date: December 9, 2024
to: James Murphy, Assistant Director of Planning, Zoning
and Building, Town of Palm Beach
from: Eric Czerniejewski, P.E., ENV SP
subject: Palm Beach Synagogue Traffic Review

MEMORANDUM

The Corradino Group, Inc (Corradino) has been requested to provide a traffic review of the Traffic Impact Statement for the Palm Beach Synagogue redevelopment located at 120 and 132 North County Road in the Town of Palm Beach, Florida. The following are our traffic review comments based on the 11/06/24 and 12/02/24 resubmittals.

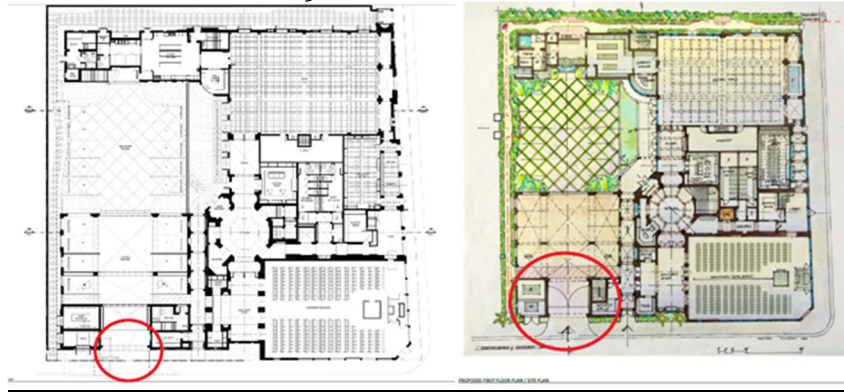
6. Please provide a 95th Percentile Vehicle Queueing Analysis Section in the updated Traffic Impact Statement. This Section should include a table that summarizes the 95th percentile vehicle queues for the key turn lanes at the signalized intersections. The table should include the existing turn lane storage and the 95th percentile vehicle queues at all key turn lanes at signalized intersections for each scenario. Please provide a narrative and report out any turn lanes where the 95th percentile vehicle queue extends past the available storage length.

Simmons & White's 09/23/24 Response: A 95th percentile queue analysis has now been provided. See Section 7.0 and Tables 12-14 in the revised traffic study.

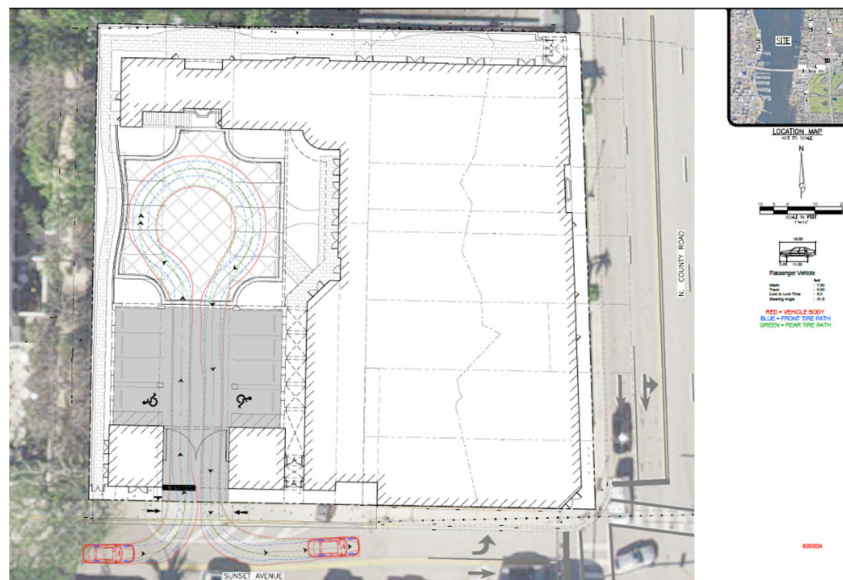
12. Please confirm if valet parking will be provided for the proposed Church use. Please provide a valet parking analysis if valet parking is going to be provided.

Simmons & White's 09/23/24 Response: Valet is not proposed for the main Synagogue use. However, the Synagogue will use valet service on occasion for large events held at the facility such as a wedding. The Synagogue uses Palm Beach Parking who parks vehicles offsite. See Section 10.0 (Valet Operations) for additional information.

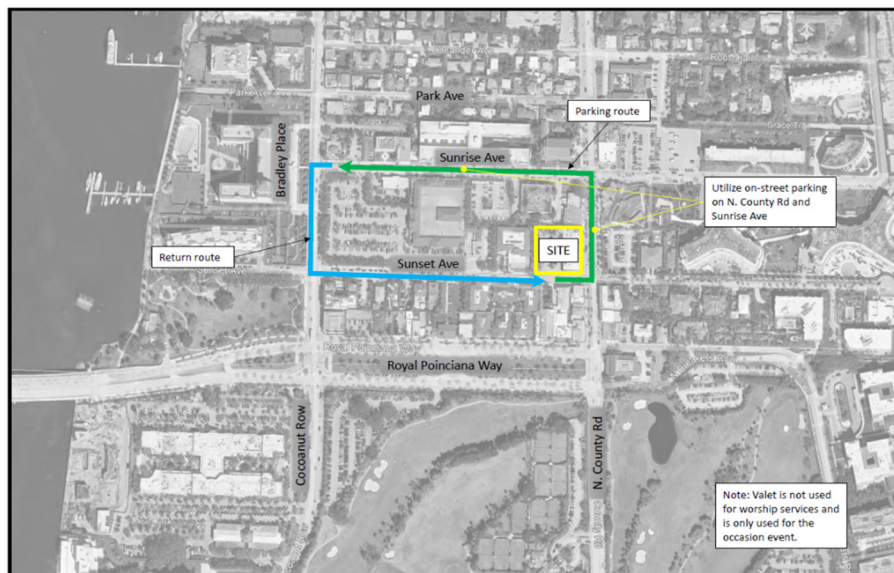
15. The proposed valet routing plan for a special event (weddings) indicates the use of the on-street public parking spaces along N. County Road (between Sunrise Avenue and Sunset Avenue) and Sunrise Avenue (between Bradley Place and N. County Road). Since these parking spaces cannot be reserved, what is the plan for special events if these parking spaces are full?

Simmons & White's 11/06/24 Response: From discussions with Palm Beach Parking, they have never had to park vehicles at a different location for Palm Beach Synagogue as there has always been more than adequate spaces available. However, in the event these spaces were filled, they would look for other on-street parking opportunities such as Royal Poinciana Way.

TCG 12/09/24 Response: This item is still pending. Please clarify the use of off-street parking lots versus the off-street parking spaces within the public road right-of-way. Please reference Comment #19.
